CITY OF ALBUQUERQUE

RE: 411 Cedar St. NE
Grading & Drainage Plan
Engineer's Stamp Date: 04/04/24
Hydrology File: K15D167

GRADING AND DRAINAGE PLAN

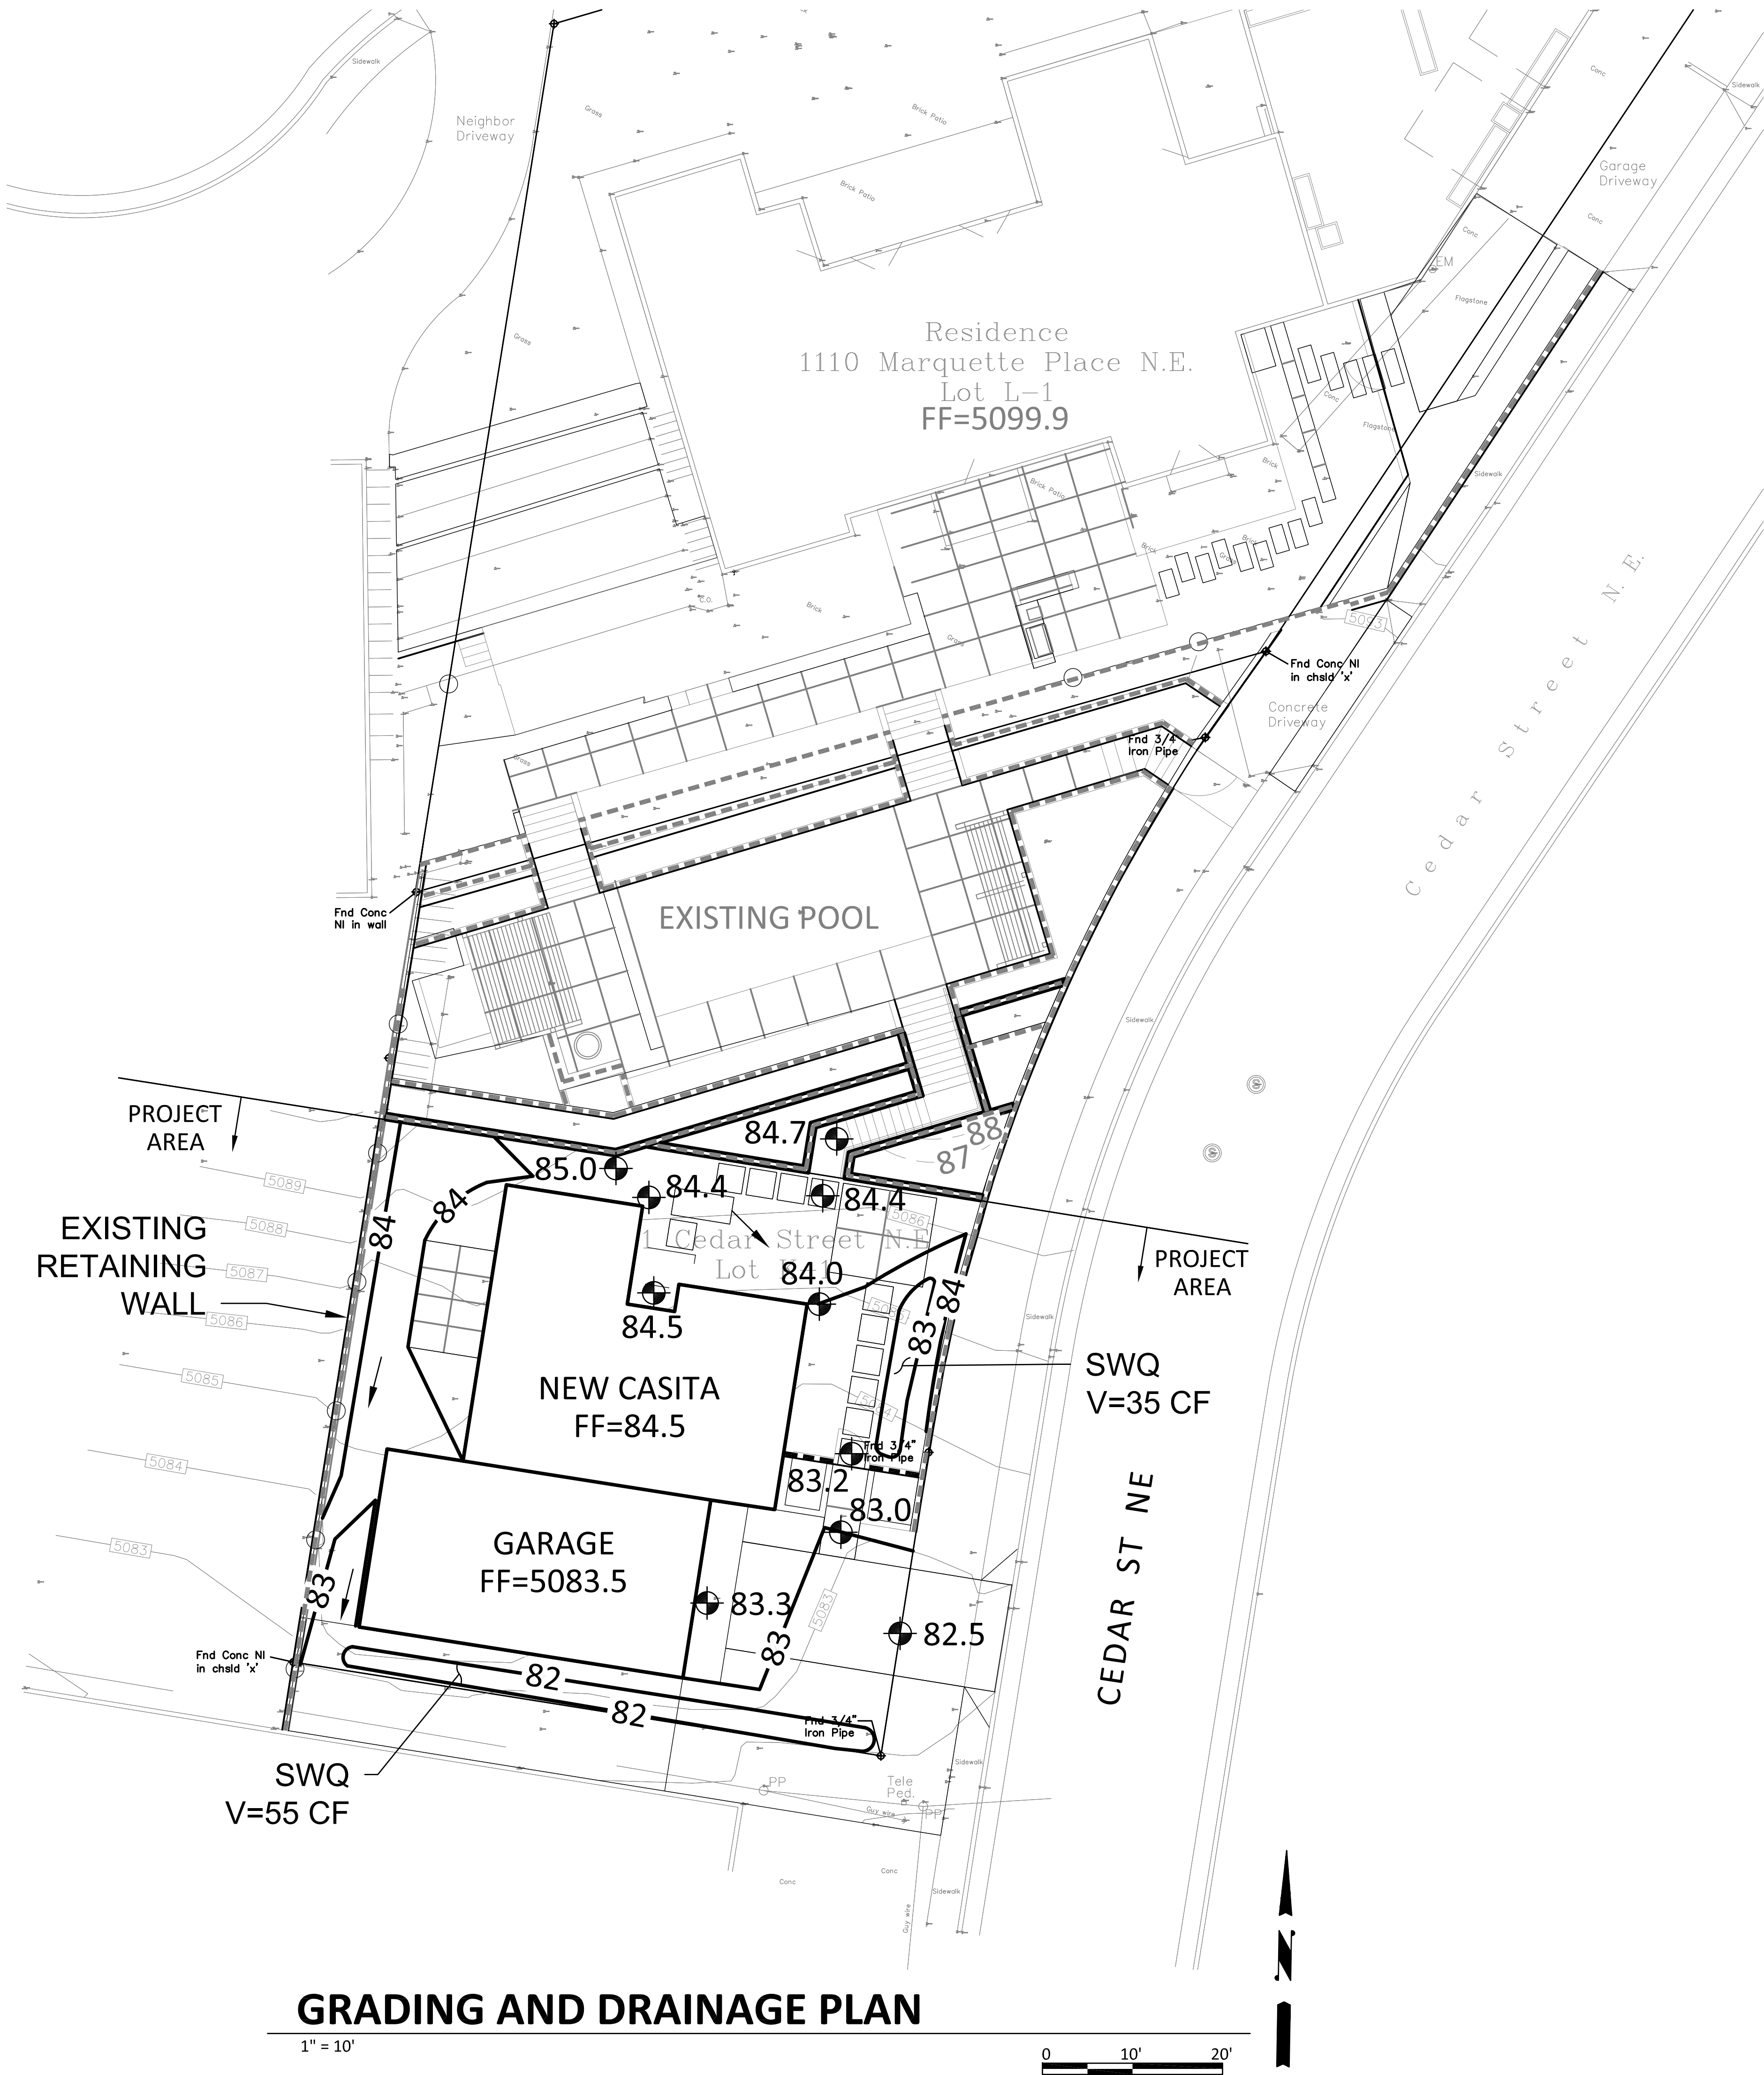
Based upon the information provided in your submittal received 04/04/2024, the Grading and Drainage Plan is approved for Building Permit and Grading Permit. **Since this project is a secondary structure on a lot with an existing house, a pad certification is not needed for this project.** Please attach a copy of this approved plan in the construction sets for Building Permit processing along with a copy of this letter.

1. Engineer's Certification, per the DPM Part 6-14 (F): Engineer's Certification Checklist For Non-Subdivision is required.
